1 ADDENDUM #2

.1 Reference Drawings Item 1.2.2 - Drawing A1-101 New Roof Plan:

1 NEW ROOF PLAN - PARTIAL
ASK-101R1 1:200

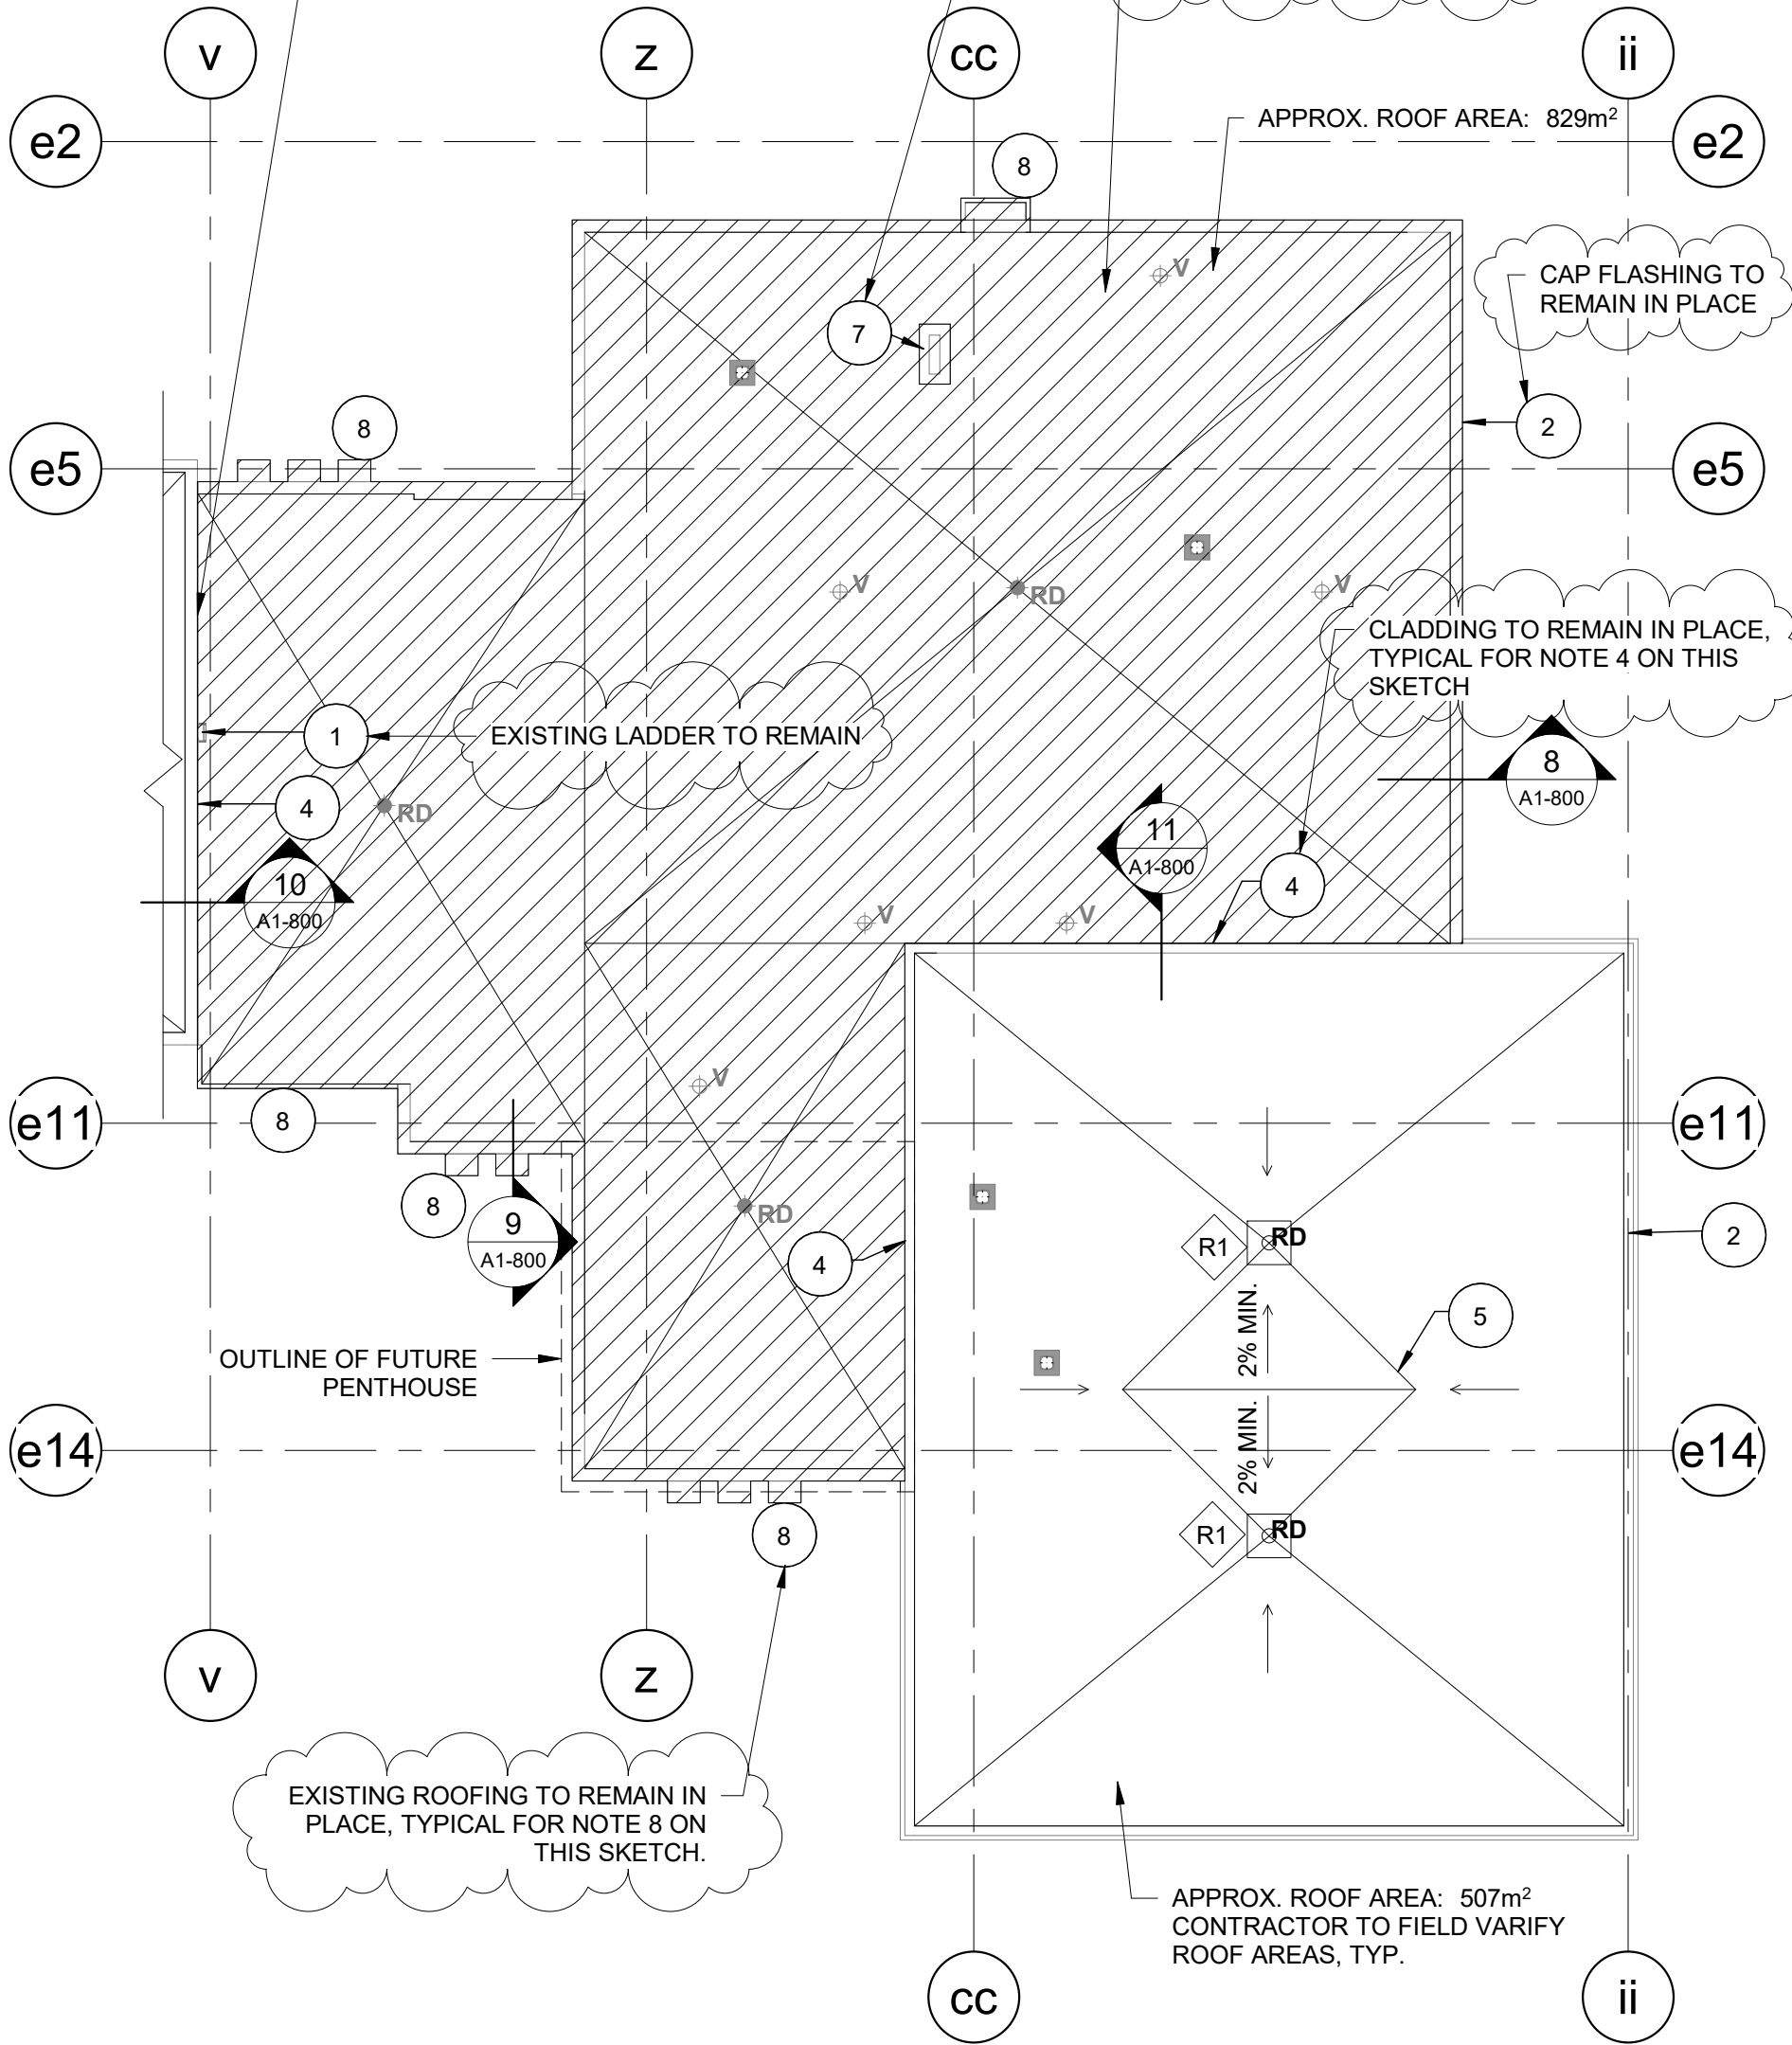
- .1 Do not re-roof the area noted in attached sketch ASK-101R1. This area will be re roofed in the future.

UPPER ROOF CAP FLASHING IS TO BE REPLACED PRIOR TO RE-INSTALLING THE NEW CAP FLASHING. RELOCATE THE SCREWS ON THE TOP ROW OF THE METAL WALL CLADDING SO THEY ARE BELOW THE NEW CAP FLASHING. THIS WILL ALLOW THE CLADDING TO BE REMOVED IN THE FUTURE WITHOUT AFFECTING THE NEW CAP FLASHING.

CHIMNEY TO REMAIN. NO ROOF PATCHING REQUIRED.

ROOF WITHIN HATCHED AREA IS NOT TO BE REPLACED.

CAP FLASHING TO REMAIN IN PLACE

CLADDING TO REMAIN IN PLACE, TYPICAL FOR NOTE 4 ON THIS SKETCH

EXISTING LADDER TO REMAIN

EXISTING ROOFING TO REMAIN IN PLACE, TYPICAL FOR NOTE 8 ON THIS SKETCH.
